Knox County Procurement Division Addendum II to Invitation for Bid 3503 Farragut High School Roof Replacement

Addendum Date: January 18, 2024

**Farragut High School Roof Replacement
Knox County Schools
Bid #3503
MBI #231315**

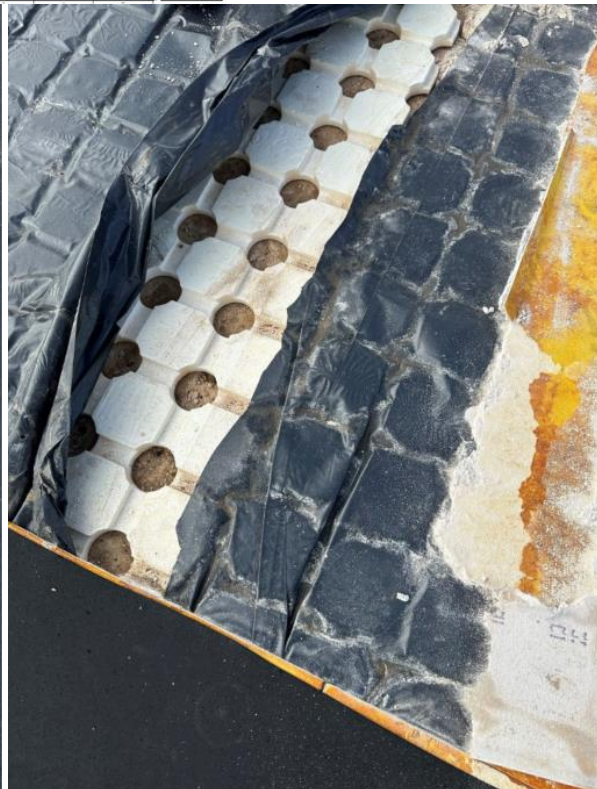
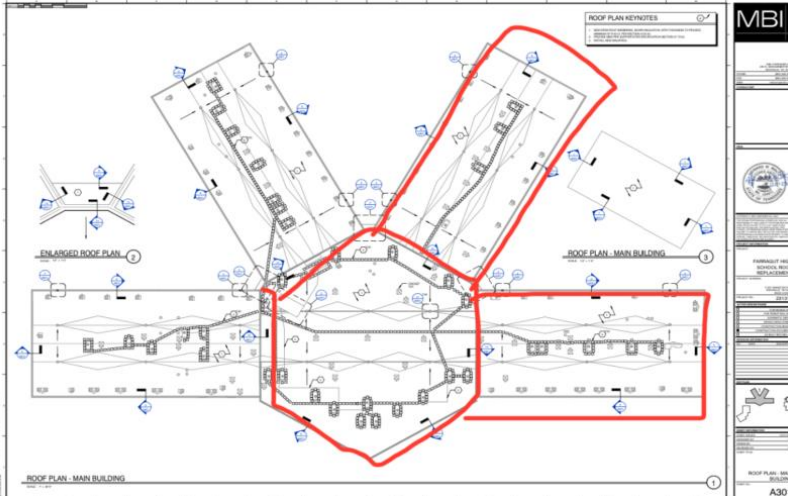
6. Do you have photos of the core sample of the roof?

Yes, See attached photos.

ROOF PLAN - MAIN BUILDING

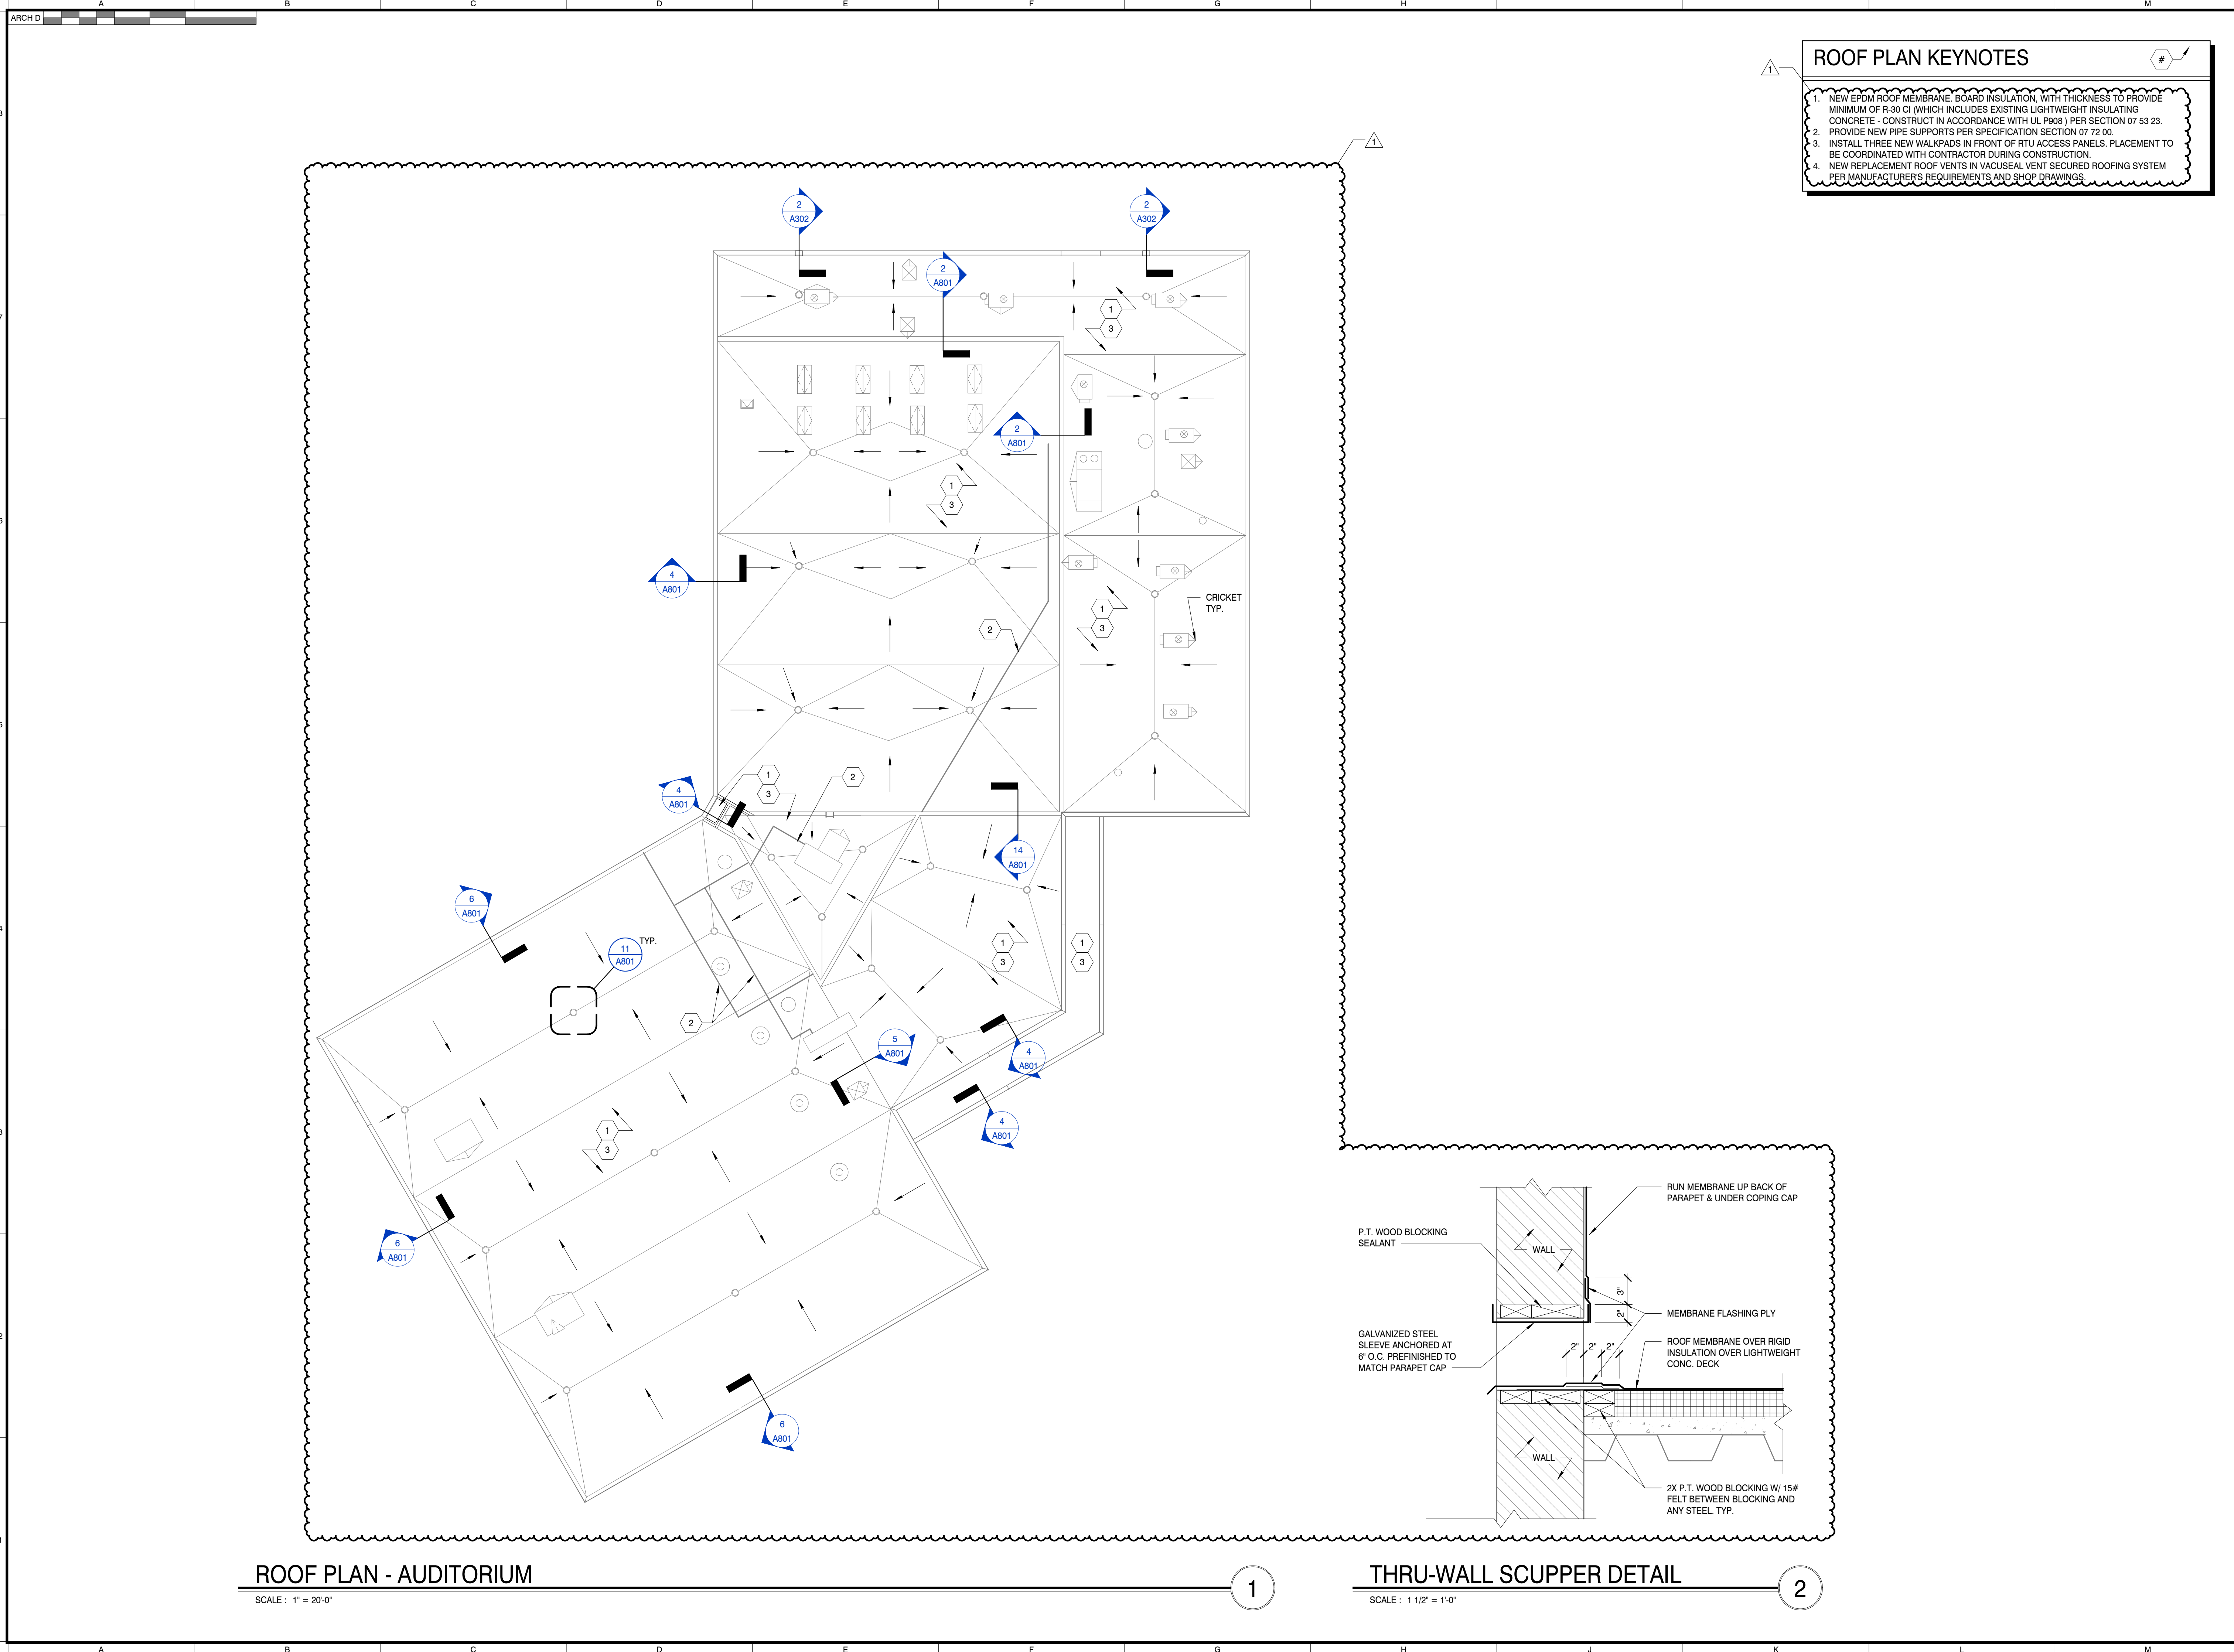
1. Only 3 walk pads per RTU are required at access panels on RTUs. Placement to be coordinated with the contractor during construction. See attached revised Roof Plan drawings.
2. Moving HVAC units and electrical conduit needs to be included in the Prime Contractor’s price.

ROOF PLAN - AUDITORIUM

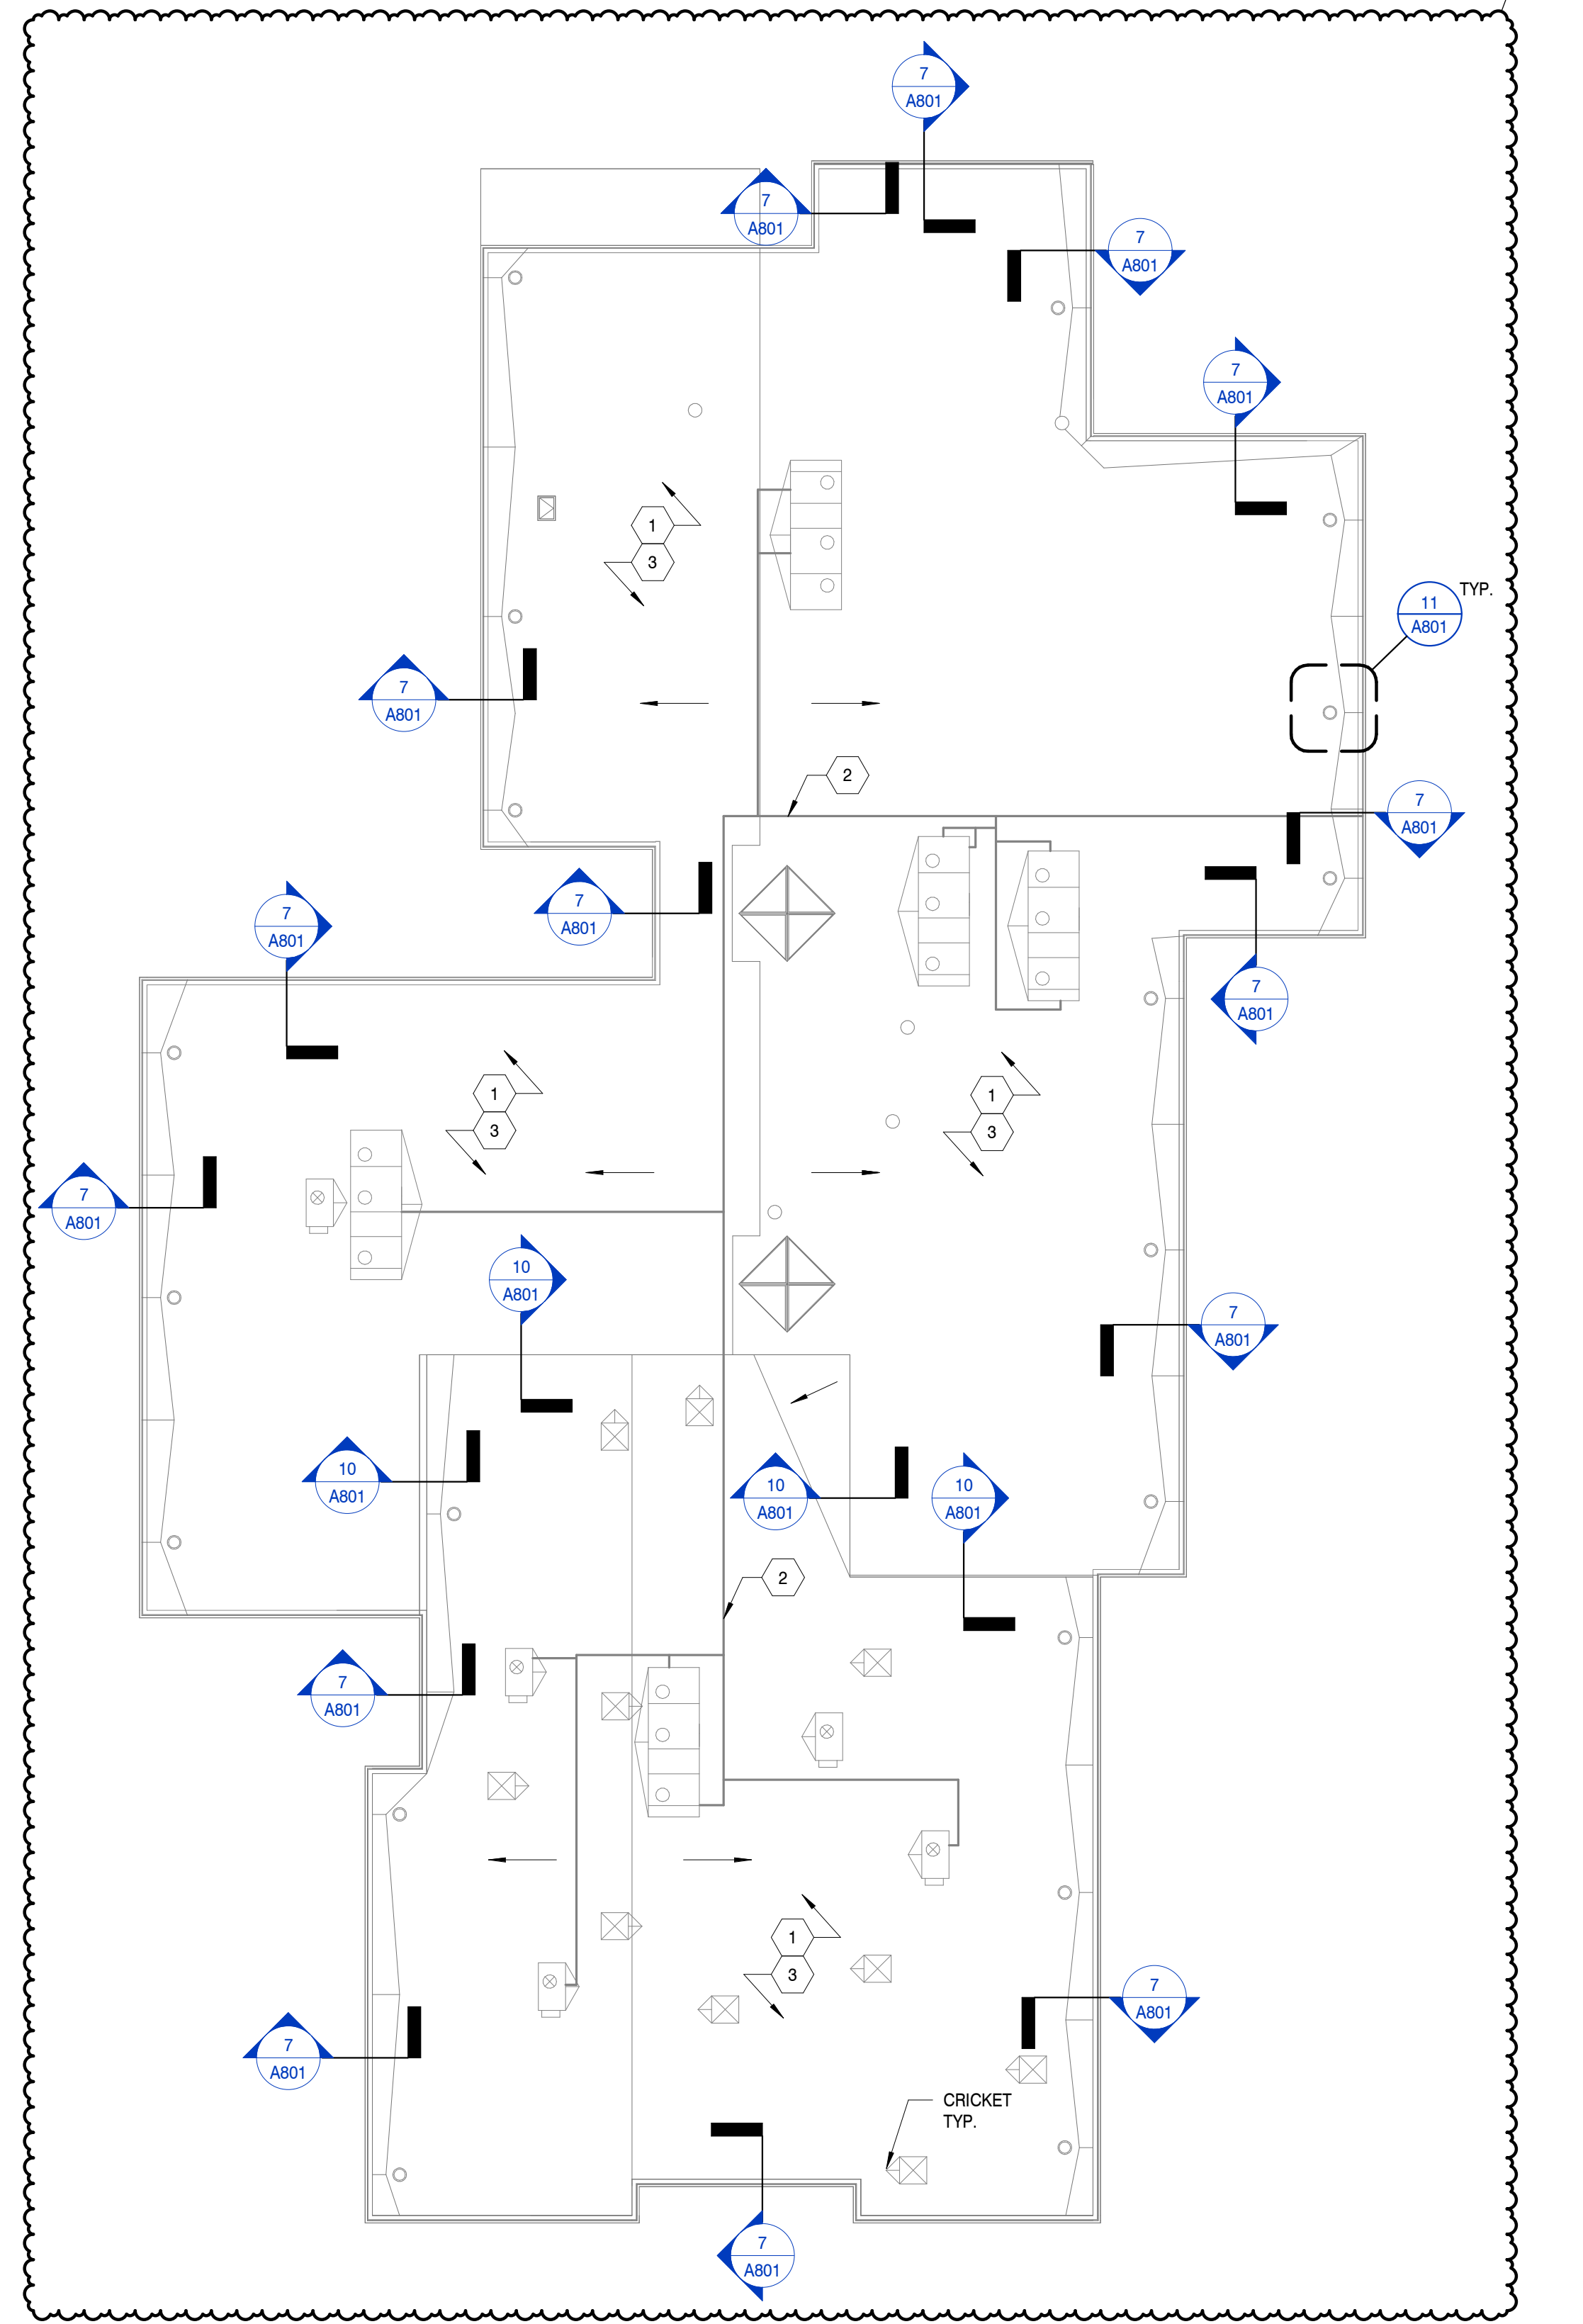
<p>3. On this low roof area there are several issues. There is no existing overflow scupper. Do you want to add an overflow to this area? If so, please provide a detail. Also, this area has elevation issues with the mechanical units and associated duct work. Will Knox County Schools utilize their own mechanical department and subs to complete the required work on these units? If not, can a mechanical bid package be provided along with ample time to procure subcontractor pricing?</p> 	<p>See parapet scupper detail and roof plan for locations.</p>
